March 22, 2021

RE: 16529 Marchmont Drive

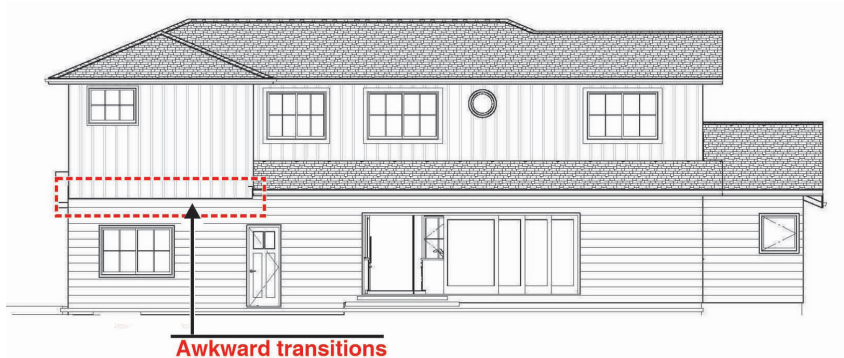
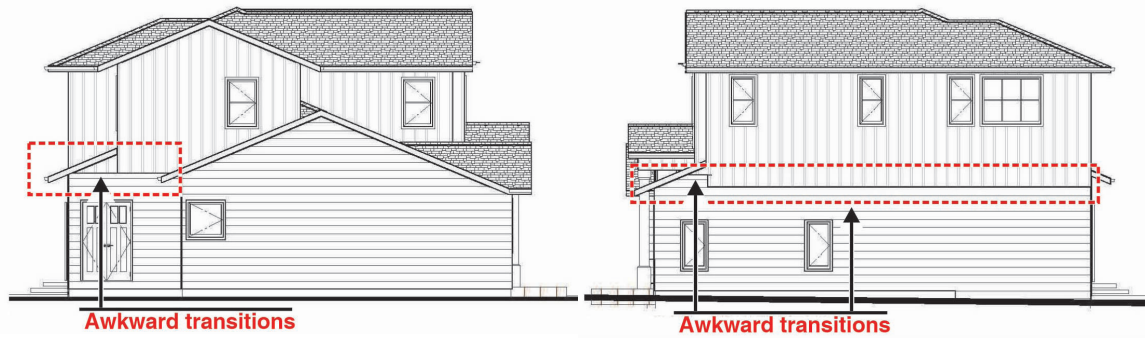
The proposed project includes a second story addition to an existing one-story house. All other homes in the immediate neighborhood are one-story Ranch Style homes. The addition is carried out in an identifiable traditional style with details appropriate to the style. While the change in style is different from the original structure, the form, scale and details would be a comfortable addition to the neighborhood.

There are, however, a few design elements that are not appropriate for this home style and/or the immediate neighborhood.

1. The entry porch is too tall, and out of scale with the house and other homes in the immediate neighborhood.
2. The treatment of the second floor bay windows creates an unbalanced composition which detracts from the general symmetry of the facade.
3. The entry porch is set off center with respect to the overall facade treatment.
4. The roof eave on the left side of the entry, and the roof transition with the adjacent roof is awkward.
5. Metal roofing is added at front first floor gable as if this were an attached porch, which it is not.
6. There are several places where the lower and upper wall siding treatments meet in awkward situations
